## Inspection and/or replacement of the valve push-rod assy., rocker arm left and rocker arm right for ROTAX® Engine Type 912 i, 912 and 914 (Series)

ATA System: 72-30-00 Cylinder head

## SERVICE BULLETIN

*Fig. 1*  
*Visual inspection*

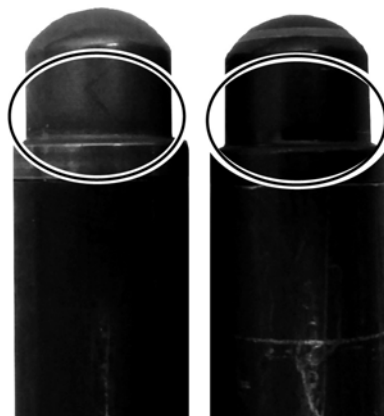
Perform visual inspection of all push-rod ball sockets on all cylinder.  
 Check for color. See Fig. 1.

Color	Evaluation
Silver surface	Valve push-rod is OK. No further action required for this valve push-rod.
Black surface	Valve push-rod is NOT OK. See section. <a href="#">3.1.3) Replacement of affected parts.</a>

Fig. 2

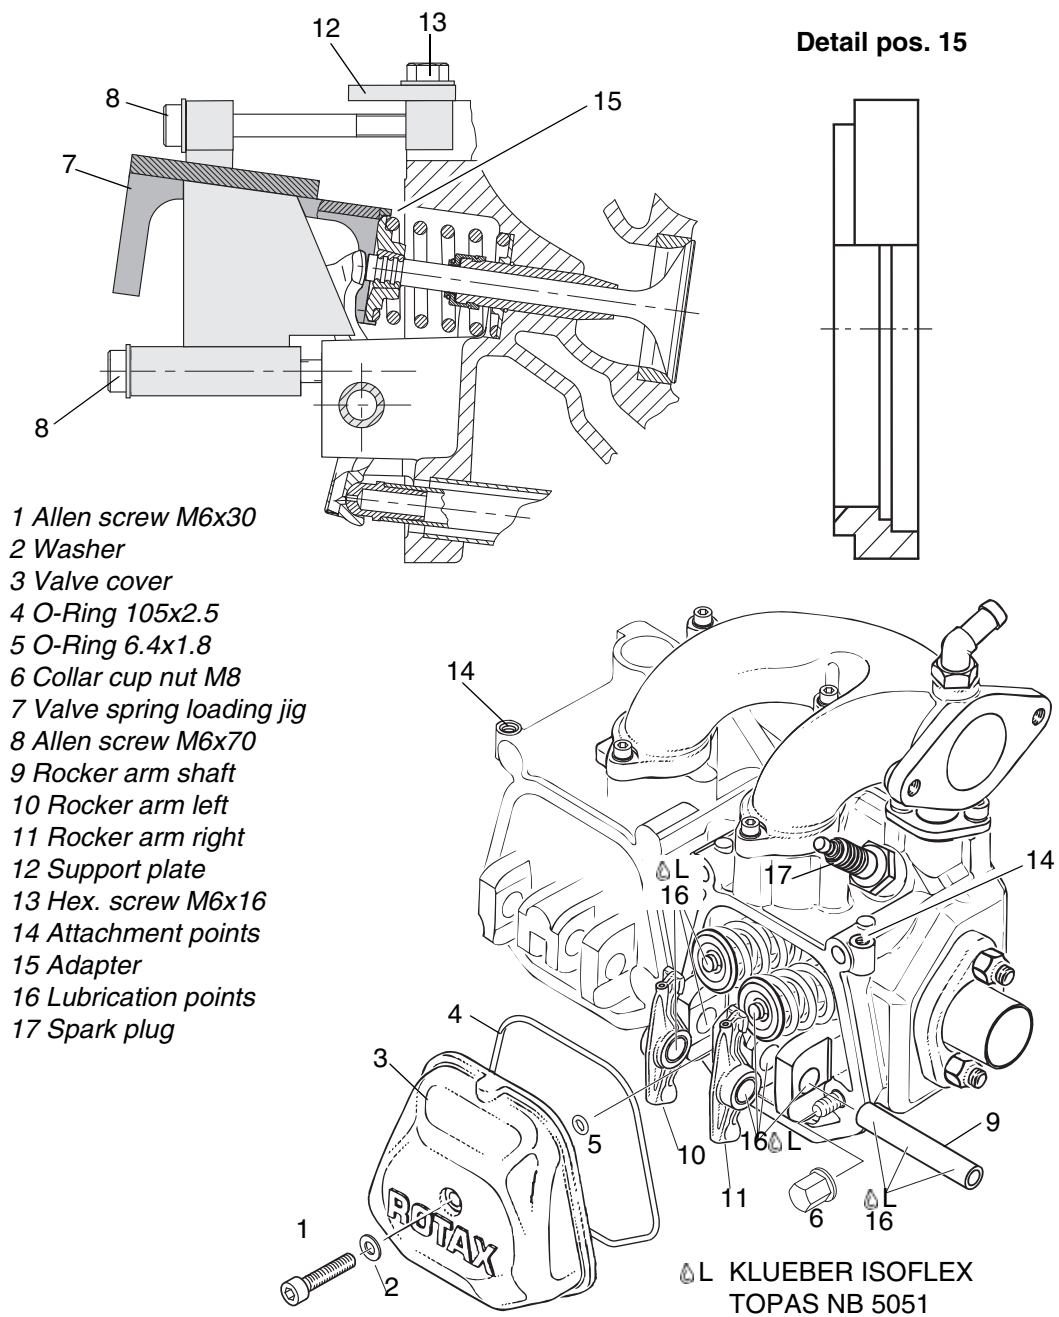
See Fig. 2.

Step	Procedure
1	Loosen Allen screw (1) M6x30 with washer (2) from valve cover (3), and remove it together with large and small O-rings (4) and (5).

See [Fig. 2](#) and [Fig. 3](#).

Step	Procedure
2	Turn crankshaft so that the respective piston is exactly on ignition top dead center. NOTE: Only when you have an Criterion B) Spare parts affected engine and only if engine is equipped with collar cap nuts M8 wrench size 13: Loosen the external collar cap nut (6) for easier disassembling the rocker arm shaft.

Step	Procedure
3	Attach the support plate (12) to the valve spring loading jig part no. 877387 (7) with 2 hex. screws (13) M6x16 at the attachment points (14) on the cylinder heads.
4	Put adapters (15) on the valve spring loading jig.
5	Attach the valve spring loading jig on cylinder head and support plate with 2 Allen screws (8) M6x70 and depress both valves with 3 turns.

Step	Procedure
6	This will relieve the pressure from both hydraulic tappets. Now the rocker arm shaft (9) may be easily pulled out. Lift out both rocker arms (10) and (11). NOTE: If you cannot pull out the rocker arm shaft easily, you will need to contact an ROTAX® Authorized Distributor for further action.
7	Replace all affected parts including push rods and rocker arms. See also Fig. 3.
8	Apply KLÜBER ISOFLEX TOPAS NB 5051 (16) on both push-rod ball sockets and contact areas of rocker arm and slide push-rod into the oil return tube (20).
9	Install rocker arm bushing into rocker arm left (10) and rocker arm right (11). Put oil on the rocker arm bushing.
10	Place rocker arm left (10) and rocker arm right (11) in cylinder head, apply KLÜBER ISOFLEX TOPAS NB 5051 (16) on rocker arm shaft (9) and insert it into its bearing support.
11	Loosen valve spring loading jig and support plate.
12	When removing the valve spring loading jig, make sure the adapter rings (15) do not jam on the valve spring retainer.

13	NOTE: Only when you have an Criterion B) Spare parts affected engine and only if engine is equipped with collar cap nuts M8 wrench size 13: Mount collar cap nut (6) according to latest Maintenance Manual Heavy or SI-912-025/SI-914-026/SI-912 i-010.
14	Lubricate all moving parts in the rocker arm space with engine oil or equivalent.
15	Clean the sealing surface of cylinder head and valve cover with a suitable lint-free cloth or equivalent.
16	Insert new O-ring (4) 105x2.5 and O-ring (5) 6.4x1.8 into the valve cover (3).
17	Fit valve cover.

Step	Procedure
18	Tighten the new Allen screw (1) M6x30 with washer (2) to 10 Nm (89 in.lb).
